SUNDRY NOTICES AND REPORTS ON WELLS
Do not use this form for proposals to drill or to re-enter an abandoned well. Use form 3160-3 (APD) for such proposals.

8. Well Name and No.
VACA DRAW 20-17 FEDERAL 30H

Cimarex Energy Co. respectfully requests to run Bulk Lines instead of Flowlines and to upsize the Gas lift line.

CIMAREX ENERGY CO.
VACA DRAW 20-17 FEDERAL
FLOW LINE NETWORK ON BLM LANDS IN
SECTION 20, T25S, R33E, N.M.P.M.
LEA COUNTY, NEW MEXICO

FILE: 64534-A-1 Sheet 1 of 3

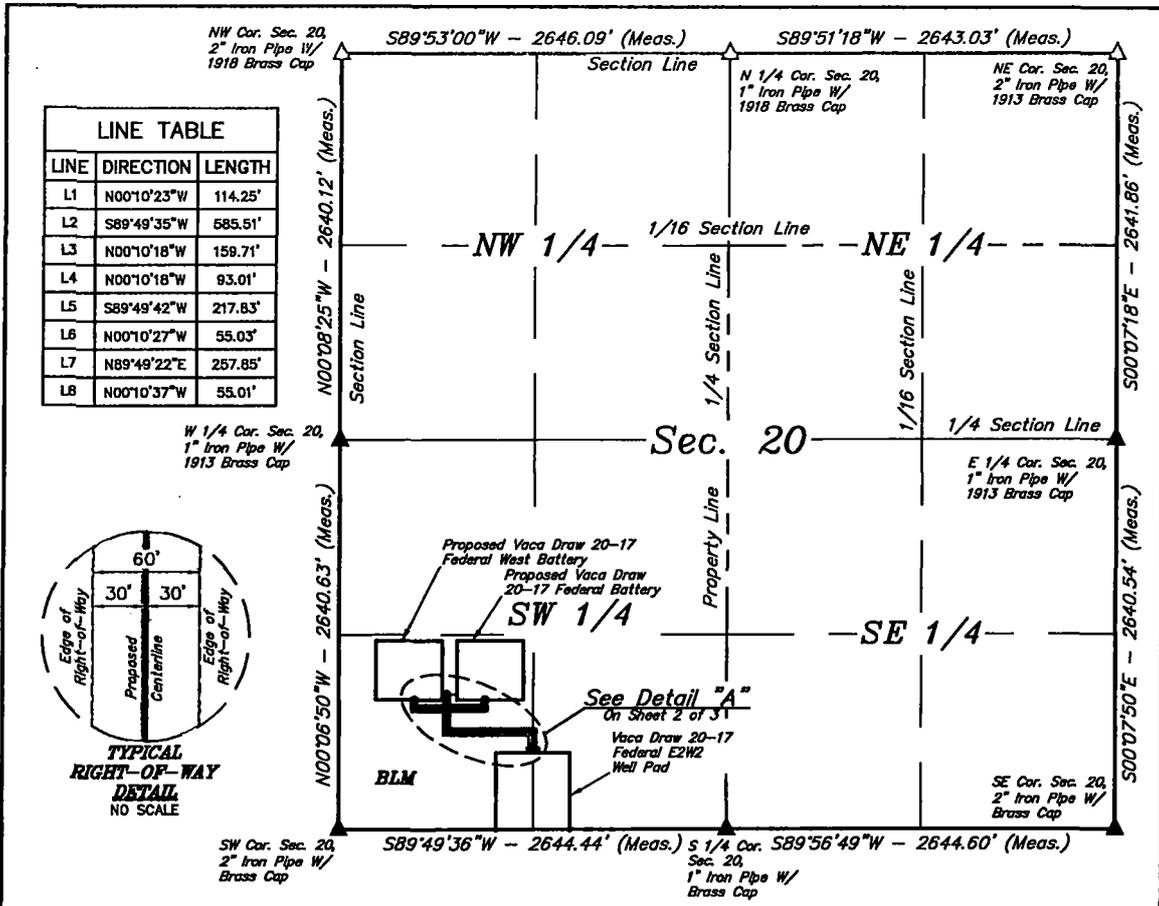
Description of lines within the approved 60' Corridor:
Same 1538' route as analyzed and approved in the Vaca Draw 20-17 Federal 30H APD.
1- 12" Buried steel Oil Bulk line
1- 12" Buried steel Gas Sales Bulk line
1- 12" Buried steel SWD line
1- 8" Buried Steel Gas lift line

There is no new surface disturbance.
